# Access Compliance Report

## Public Rights-of-Way

### (Curb Ramps)

Intersection ID: 8697	Main Street: HOLLAND_AV	Cross Street: ISENHOUR_ST	Location: NE
ADA ID: CA6FECDE2C2B	Ramp Type: PerpDiag	Initial Pass/Fail: Fail	Overall Compliance: No
		Severity Score: 42.5

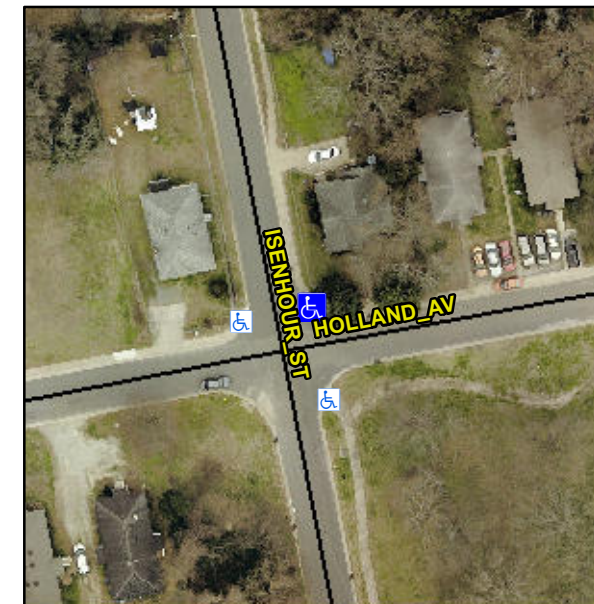
**Not Found, R304.5.1, R304.5.3**

Compliance	Description	Data	Compliance	Description	Data
N/A	Ramp Length (in)	47.0	Yes	Ramp Slope (%)	6.5
No	Ramp Width (in)	32.0	No	Ramp XSlope (%)	9.7
N/A	Flare Type LT	N/A	N/A	Flare Type RT	N/A
N/A	Flare Slope LT (%)	N/A	N/A	Flare Slope RT (%)	N/A
N/A	Flare Traversable LT?	N/A	N/A	Flare Traversable RT?	N/A
N/A	Landing Length (in)	N/A	N/A	DWS Provided?	N/A
N/A	Landing Width (in)	N/A	N/A	DWS Contrast?	N/A
N/A	Landing Slope (%)	N/A	N/A	DWS Length (in)	N/A
N/A	Landing X Slope (%)	N/A	N/A	DWS Full Width?	N/A
N/A	Landing Curb? (Y/N)	N/A	N/A	DWS Offset (in)	N/A
N/A	Shared Landing?	N/A			
N/A	Gutter Ponding?	N/A	N/A	Gutter Slope (%)	N/A
N/A	Gutter Lip Ht (in)	N/A	N/A	Gutter X Slope (%)	N/A
N/A	Painted X Walk1?	No	N/A	Painted X Walk2?	No
	X Walk 1 Direction	To W		X Walk 2 Direction	To S
N/A	X Walk 1 Width (in)	N/A	N/A	X Walk 2 Width (in)	N/A
	X Walk 1 Slope (%)	3.7		X Walk 2 Slope (%)	5.9
	X Walk 1 X Slope (%)	7.9		X Walk 2 X Slope (%)	0.4

**Remove & Replace Curb Ramp With Two New Directional Ramps or Equivalent.**
